Docket No. 52-002

Subject: Human Factors Engineering - Revised RAI Responses

REVISED RESPONSES TO NRC REQUESTS FOR ADDITIONAL INFORMATION
I&C AND HUMAN FACTORS RAIs

FIGURE 620.30-1
 NUPEX 80+ DESIGN PROCESS

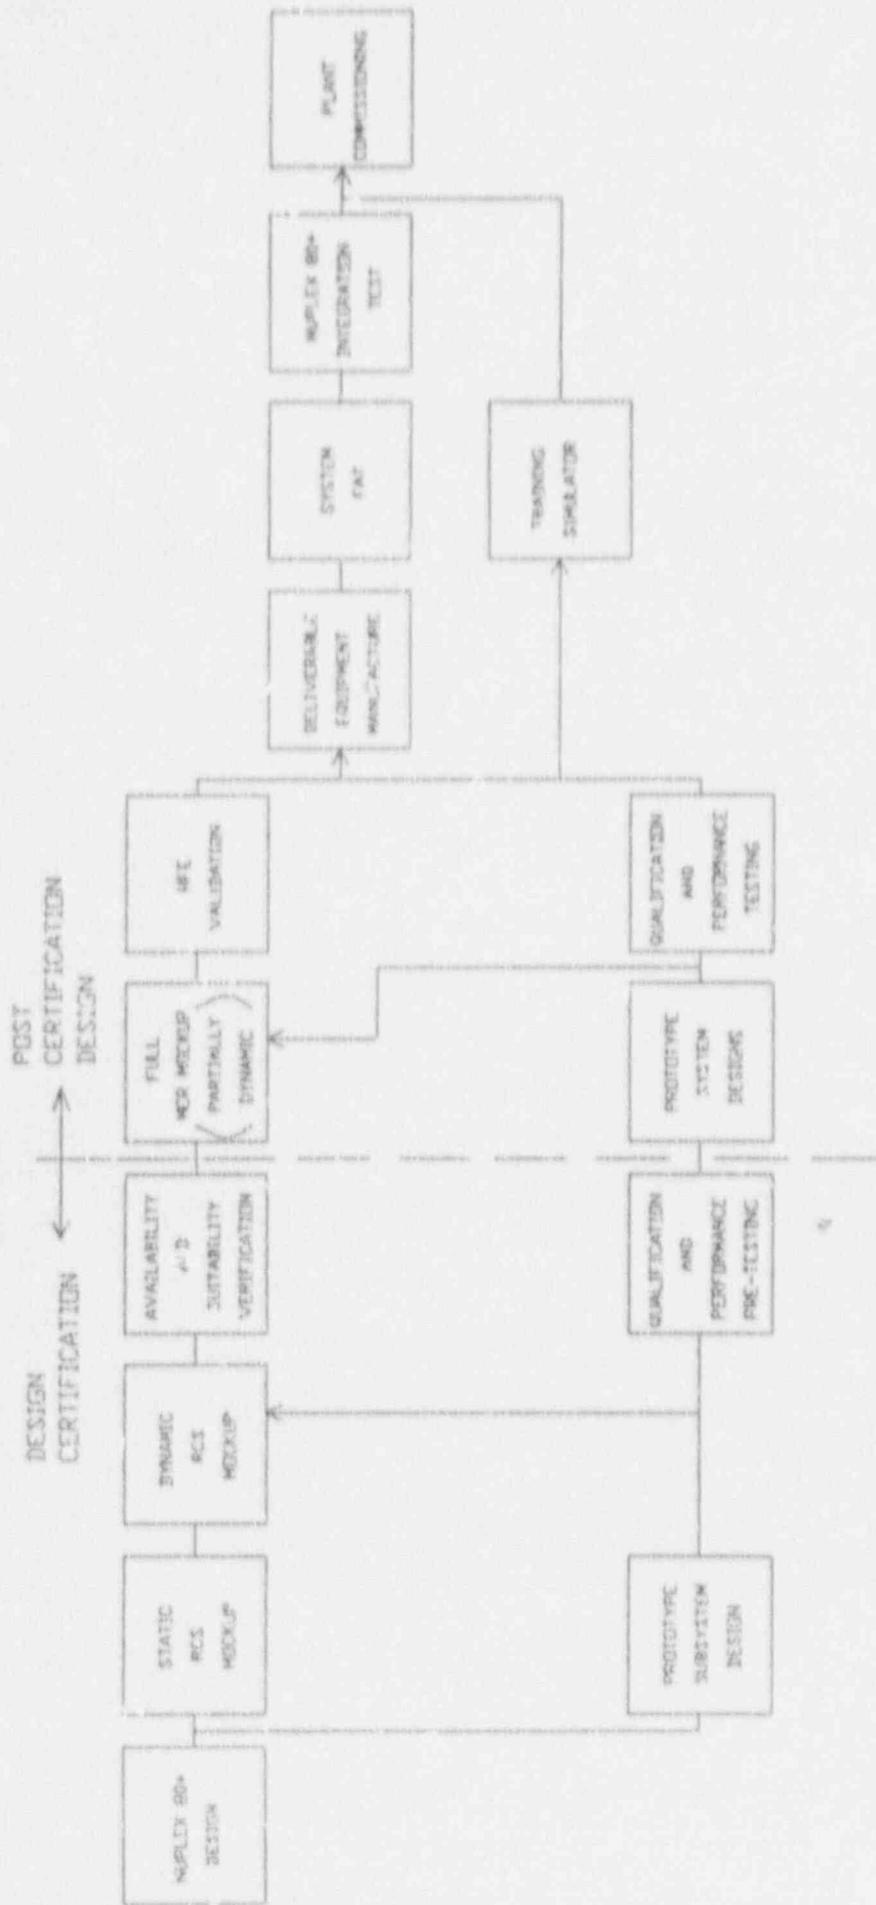
Question: Describe the human engineering test and evaluation methodologies that have been, or will be, used. How does the human engineering test and evaluation program fold into the System 80+ verification and validation program?

Response: The human factors test and evaluation methodologies can be divided into three phases: those occurring before the start of the Nuplex 80+ design, those occurring during the design certification process and those that will occur after certification. All of these test and evaluation methodologies are described in the Human Factors Program Plan for System 80+. A brief synopsis of the human factors tests and evaluations is provided in the remainder of this RAI response.

As part of first-of-a-kind engineering a full main control room mock-up will be completed with dynamic MMI components at selected panel sections. This complete, partially dynamic mock-up facility will be used to conduct a HFE validation program using operators and representative operating procedures. This is described in Section 18.9 of CESSAR-DC. Before Nuplex 80+ is delivered to a plant, a factory integration test of all systems, including a complete set of

hardware, will be performed. This will include additional human factors validation activities. The Nuplex 80+ design process, including evaluations and tests, is shown in Figure 620.30-1.
